Village of Bayside
9075 N Regent Road
Architectural Review Committee Meeting
July 8, 2024
Village Board Room 5:00pm

ARCHITECTURAL REVIEW COMMITTEE AGENDA

Attention:
Village of Bayside, WI
Architecture Review Committee

| <p>PROJECT/SITE OWNER: Milton Pivas trust / Cheryl Pivas trust</p> <p>PROJECT ADDRESS: 8754 N Pelham Pkwy</p> | <p>PROJECT SUMMARY: New 437 sq. Ft. deck</p> |

PLAT OF SURVEY

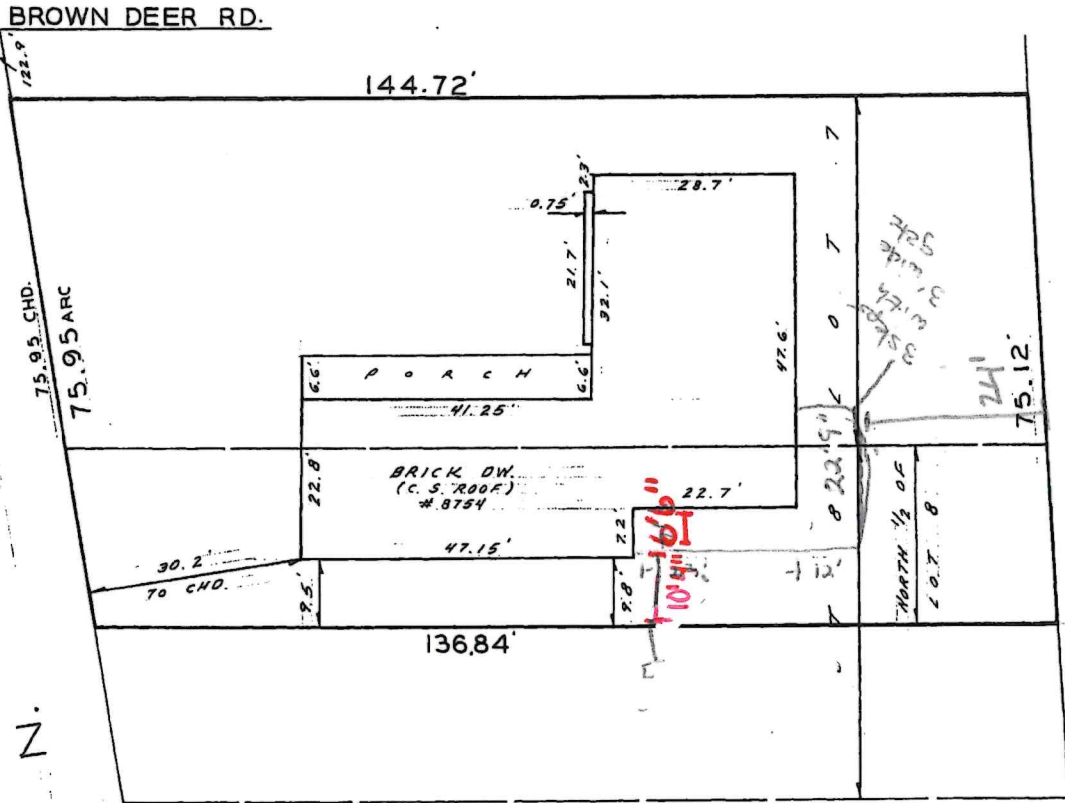
I have reviewed the proposed new deck for compliance with the Village's ordinances and have determined the following for consideration.

Sec. 125-91. - "C" residence district regulations.

1. Setbacks conform to the ordinance
2. There are no issues with this submittal
3. **This review is not for permitting.**

PROPOSED NEW FENCE

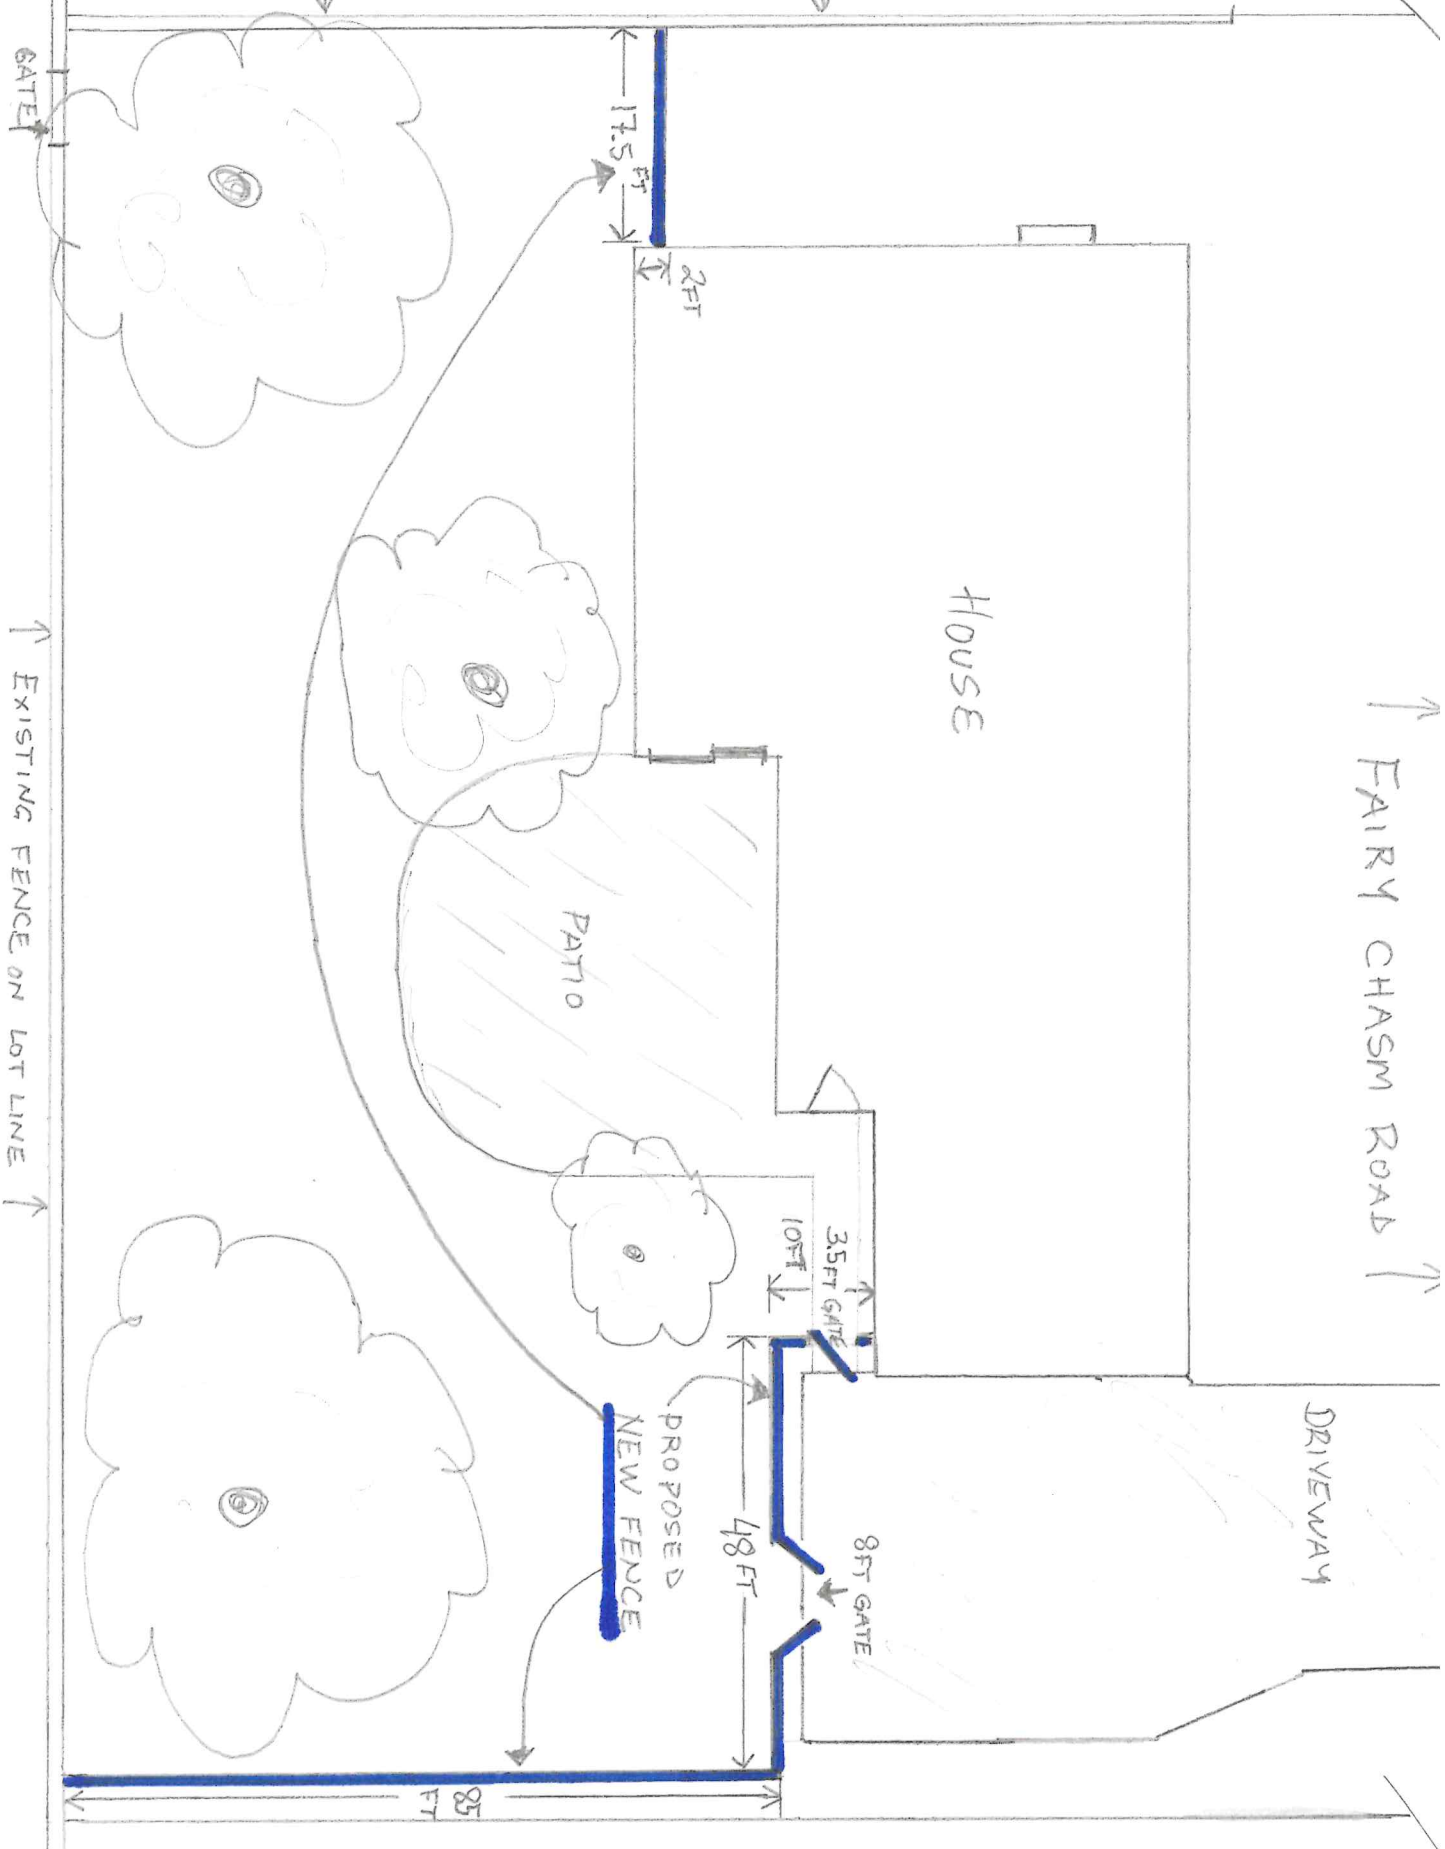
I have reviewed the proposed new fence for compliance with the Village’s ordinances and have determined the following for consideration.

1. A current survey was provided.
2. The board always considers matching fences with neighboring fences.
3. There are no issues with this application.

JOB ID: _____ TYPE: ESTIMATE LAYOUT INSTALL DATE: _____ FOREMAN: _____
 CUSTOMER: Randy Bocharitz DESIGN TECH: Justin J DATE: 6/24/2024
 SKETCH OF PROJECT:

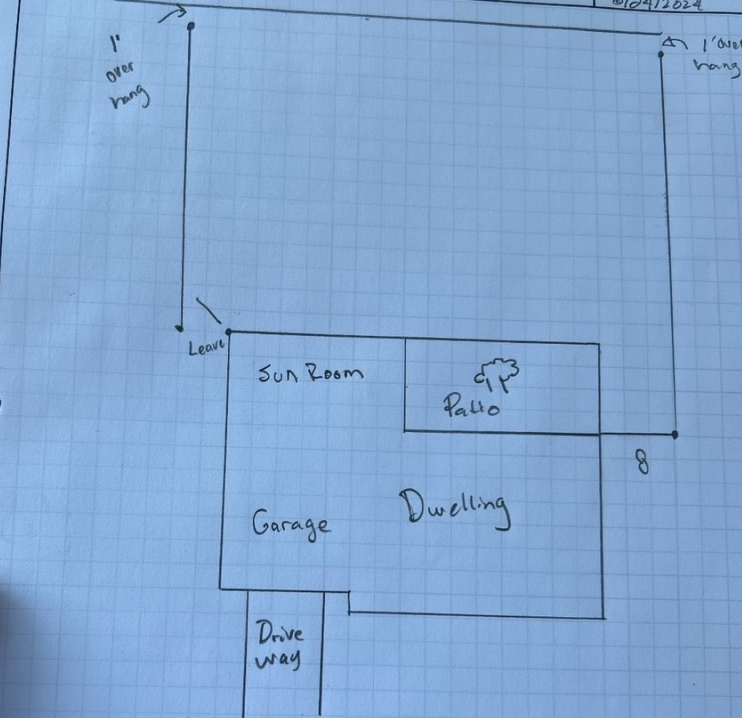
1. A current survey was provided.
2. **There was a change on the application from a privacy fence to a traditional open picket with 50% open design, this will be confirmed on final inspection.**
3. The board always considers matching fences with neighboring fences.
4. There are no issues with this application.
